**SERVICE BULLETIN NO.639**

<b>SUBJECT:</b>	Proper installation of impulse couplings
<b>REASON FOR BULLETIN:</b>	To modify, confirm and stress the importance of proper installation procedures of impulse coupling assemblies
<b>EQUIPMENT AFFECTED:</b>	All TCM & Bendix S-20, S-1200, D-2000 and D-3000 series magnetos with impulse couplings as installed on TCM, Lycoming, Franklin and other manufacturer's engines.
<b>COMPLIANCE:</b>	<b>MANDATORY AT TIME OF INSTALLATION OF ANY BENDIX/TCM IMPULSE COUPLING ASSEMBLY</b>

**FIGURE 1**

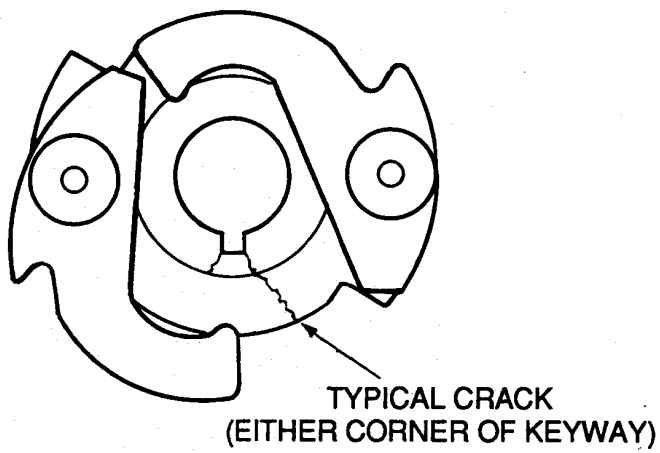
Field reports indicate that there have been instances in which the impulse coupling cam assemblies have cracked upon installation. See Figure 1. Cracking can be caused by improper installation procedures which may result in coupling assembly damage or potential engine failure.

4. Using a CALIBRATED torque wrench, tighten nut to 180 in-lbs. Install and secure new cotter pin. If unable to install and secure new cotter pin, increase torque gradually to align the first available slot in the castellated nut.

**WARNING...Under no circumstances should you exceed 300 in-lbs. torque. Any impulse coupling that is damaged in any way during installation must be replaced.**

**FIGURE 2**

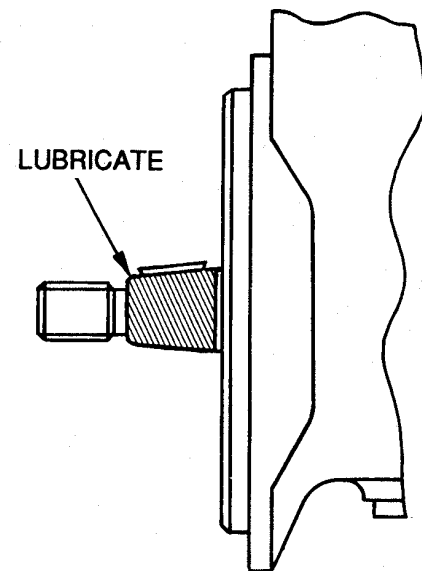
1. Clean impulse coupling assembly and magneto drive shaft using standard cleaning solvent.
2. Apply a light coating of TCM P/N 646943 anti-seize lubricant to the tapered section of the magneto drive shaft. This prevents seizure of the cam assembly to the shaft and avoids damage during disassembly. Do not apply lubricant to shaft or nut threads. See Figure 2.
3. Install woodruff key in tapered portion of the shaft. Install coupling assembly, washer(s) and thread nut onto shaft. Use approved hardware specified in the appropriate TCM Ignition Systems parts manual.

**Apply P/N 646943 Anti Seize  
Lubricant to Magneto Shaft**
